**Report to
Development Permit Panel**

To: Development Permit Panel
From: Joe Erceg
Manager, Development Applications
Date: July 9, 2003
File: DP 03-232824
Re: **Application by J.A.B. Enterprises Ltd. for a Development Permit at
7160 Blundell Road**

1 SITE PLAN
A-1 SCALE: 1/8" = 1'-0"

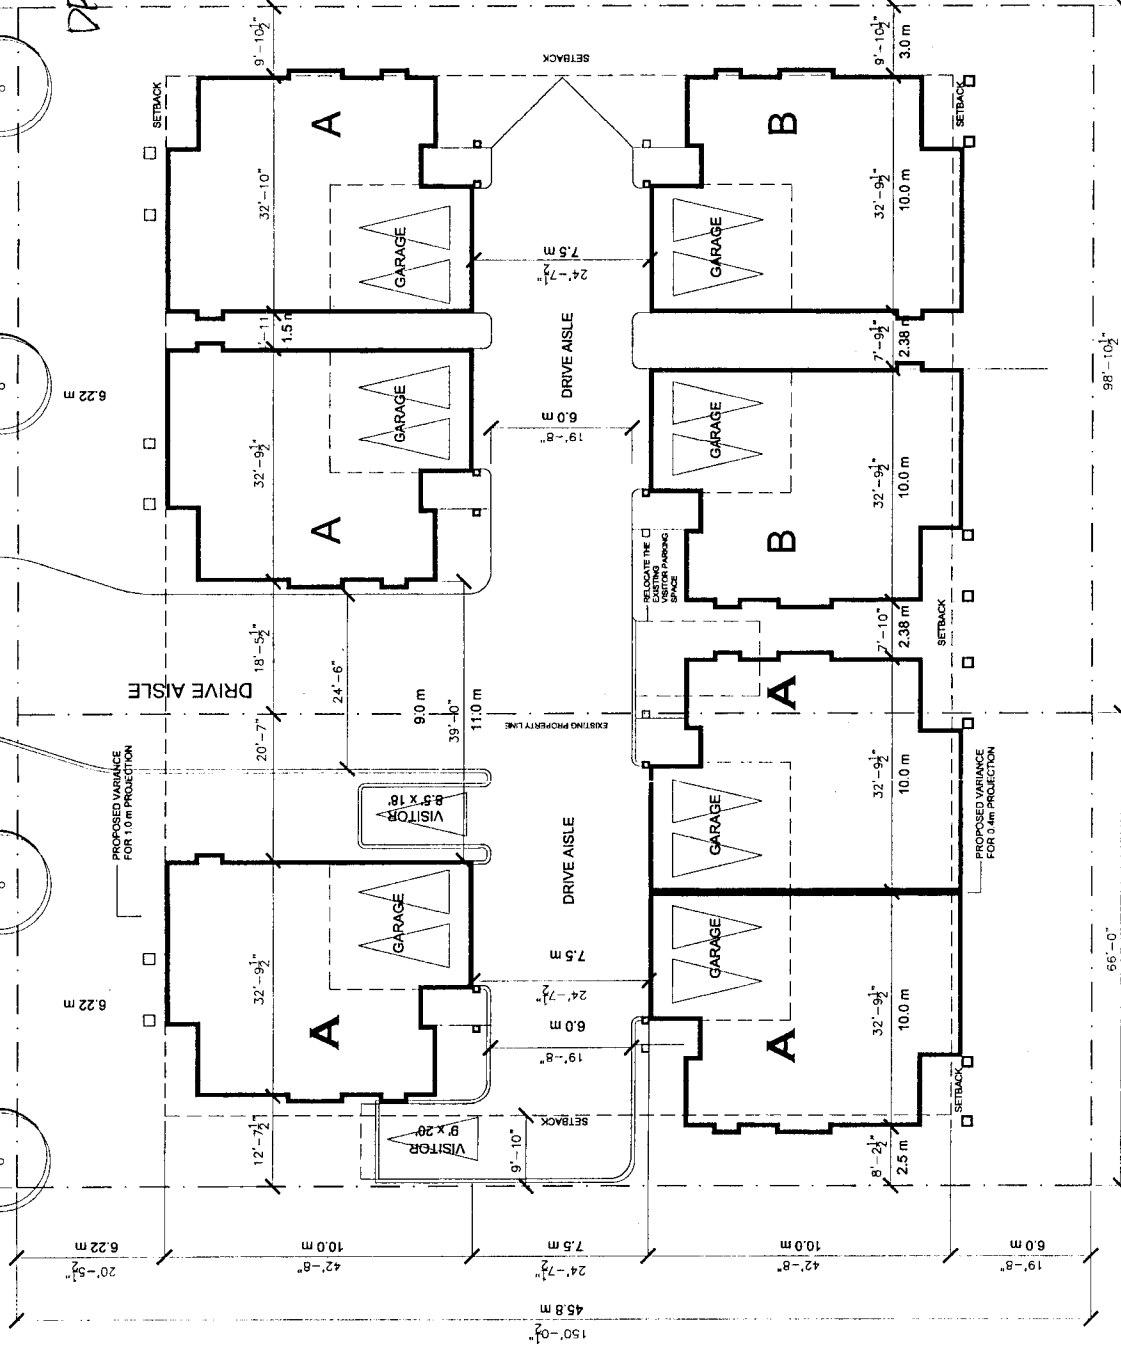
6. The driveway access to Blundell Road is a temporary access and the intention is to eventually retire this driveway access when the long-term east-west laneway is completed. The applicant was requested to provide a long-term site plan and landscape plan to illustrate the eventual elimination of the temporary access route to Blundell Road. As part of these changes to the site plan, it was recommended that the applicant relocate the two (2) visitor parking stalls along the west property line to the approximate location of the temporary driveway alignment in this future reconfiguration of the site plan. It was also suggested that the applicant eliminate the refuse/recycling enclosure. ***Complies, and a revised landscape drawing has been submitted.***

West Property Line: Along the west property line, the applicant has requested setback variances for the townhouse unit in southwest corner of the site. The applicant was requested to remove the visitor parking stall in this location in order to provide additional landscape screening and buffering for the adjacent single-family dwelling. The applicant has relocated the visitor parking stall and currently proposes a 1.5 m (6 ft.) high wood fence on the property line with minimal hedging along this portion of the east property line.

- a) Reduce the side yard setback along the west property line from 3 m (9.843 ft.) to 2.5 m (8.202 ft.) for a portion of the principal building on one (1) townhouse unit at the southwest corner of the site; and
- b) Reduce the side yard setback along the west property line from 3 m (9.843 ft.) to 2.195 m (7.202 ft.) for a 2-storey box bay window on one (1) townhouse unit at the southwest corner of the site.

It is noted that a recent text amendment associated with this site, adjusted the setback requirements for Comprehensive Development District (CD/23). The applicant now requests further minor setback variances. The applicant could revise the architectural design to eliminate these requested variances or alternatively provide appropriate landscape screening and buffering along the west property line. The applicant has not revised the architectural design or provided sufficient landscape screening and buffering along the west property line to mitigate the impacts of the requested setback variances.

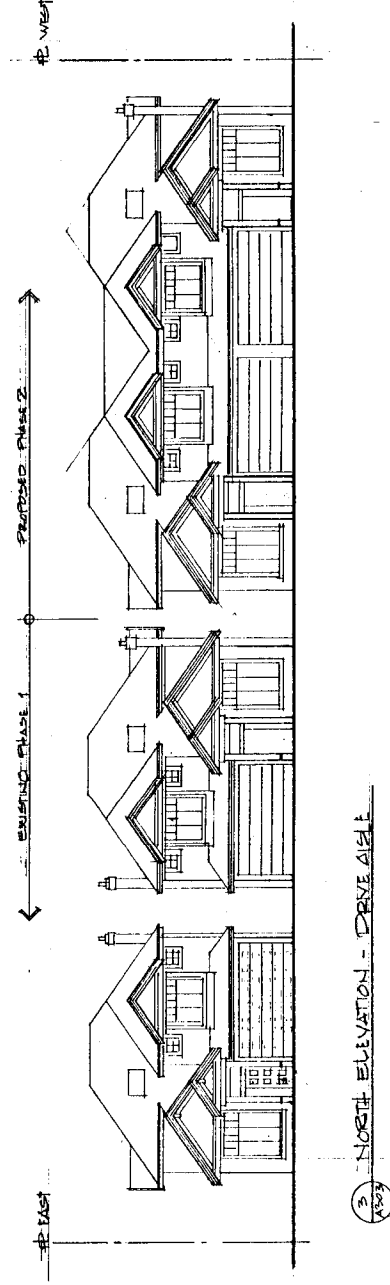
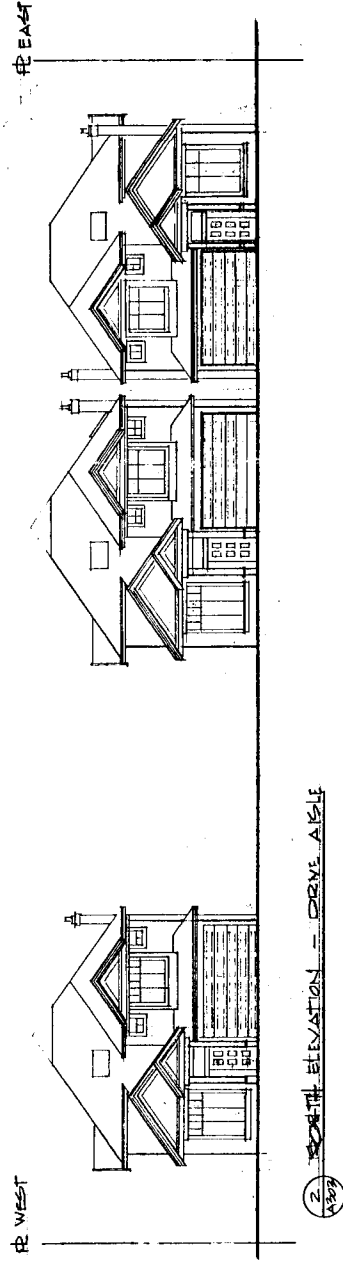
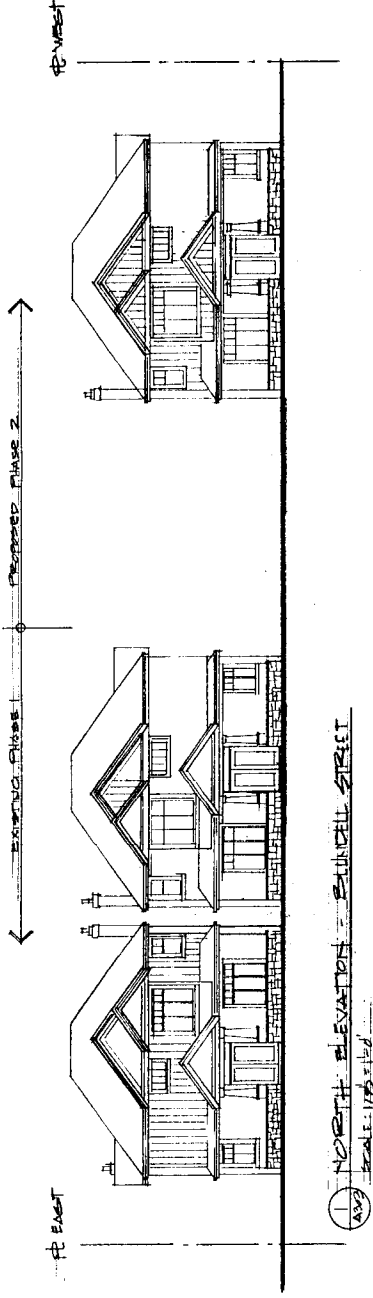
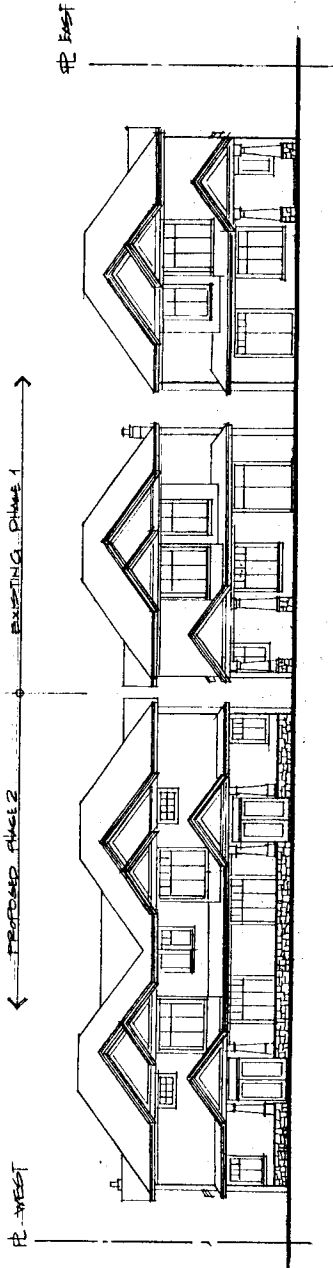
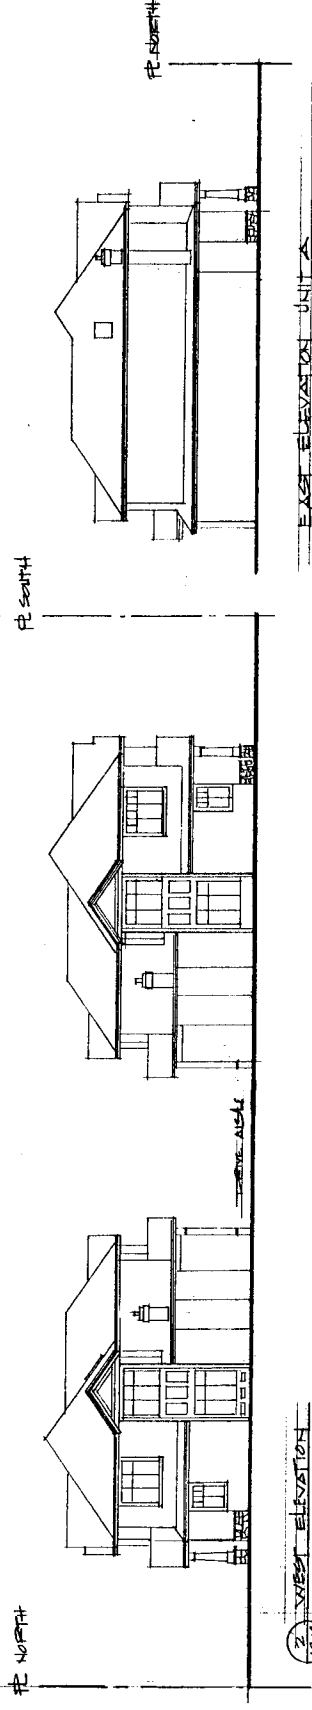
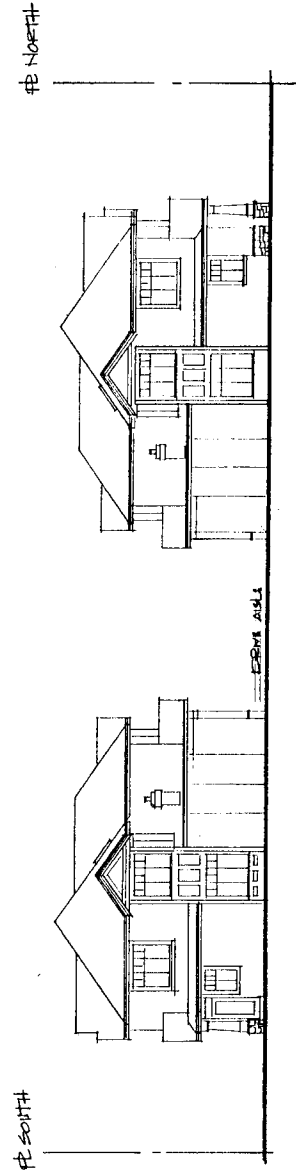
1. Provide continuous architectural building elevations for all four (4) sides of the subject site (i.e. north, east, south and west). *Complied, the applicant has provided revised drawings.*
2. The applicant was not required to present this project to the Advisory Design Panel but was requested to identify the specific proposed colours and illustrate the proposed colour scheme. *The applicant has not responded to this comment.*
